RE: 13606 Sunset Canyon Dr. NE
Grading and Drainage Plan
Engineer's Stamp Date: 03/08/21
Engineer's Certification Date: 04/05/21
Hydrology File: G23D016

Based upon the information provided in your submittal received 04/06/2021 and site photos sent on 04/06/21, the Grading and Drainage Plan is approved for Building Permit and Building Pad Certification for 13606 Sunset Canyon Dr. NE. Please attach a copy of this approved plan in the construction sets for Building Permit processing along with a copy of this letter.

ENGINEER'S SEAL	LOT 59 BLK 15 GLENWOOD HILLS U 3 13606 Sunset Canyon Dr	DRAWN BY DEM
DAVID SOULE NEW MEXICO REGISTERED PROFESSIONAL ENGINEER 14522	GRADING AND DRAINAGE PLAN	DATE 3-6-21
3/8/21	Rio Grande Engineering P.O. BOX 53924 ALBUQUERQUE, NM 87199 (505) 321-9099	13606 Sunsett Canyon Dr.DWG
DAVID SOULE P.E. #14522		SHEET # C1
		JOB #

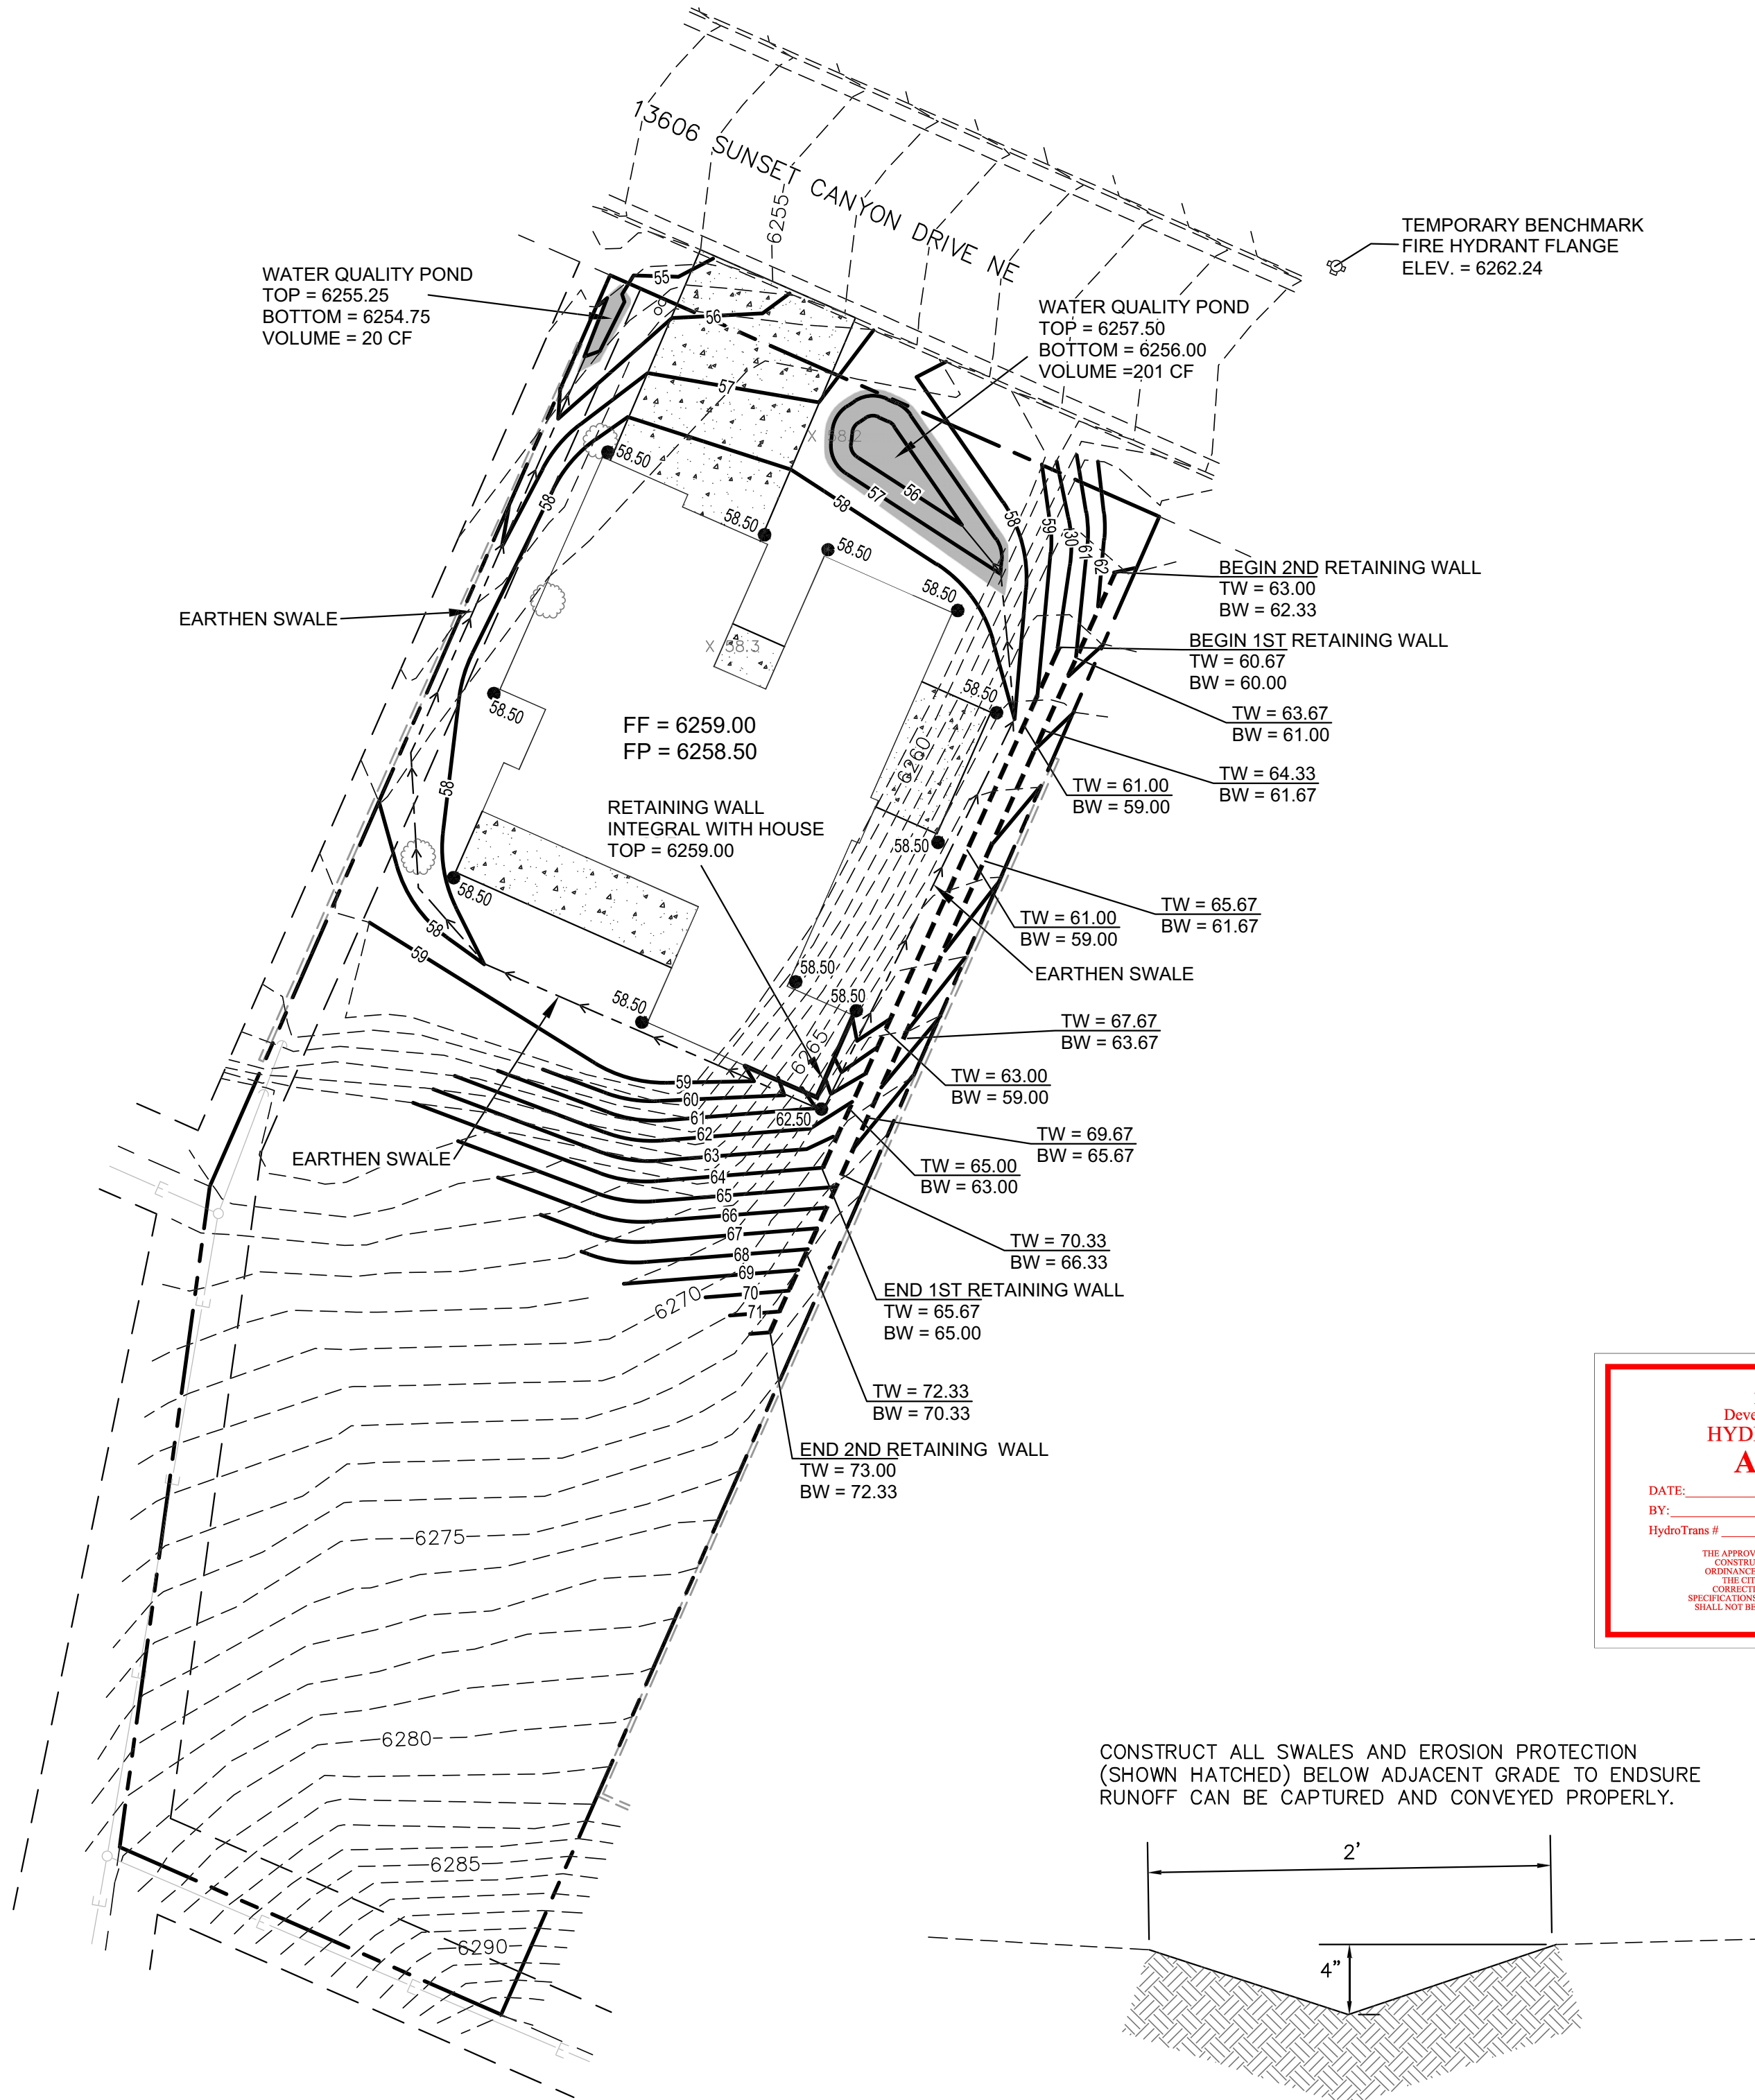
Prior to approval in support of Permanent Release of Occupancy by Hydrology, Engineer Certification per the DPM checklist will be required.
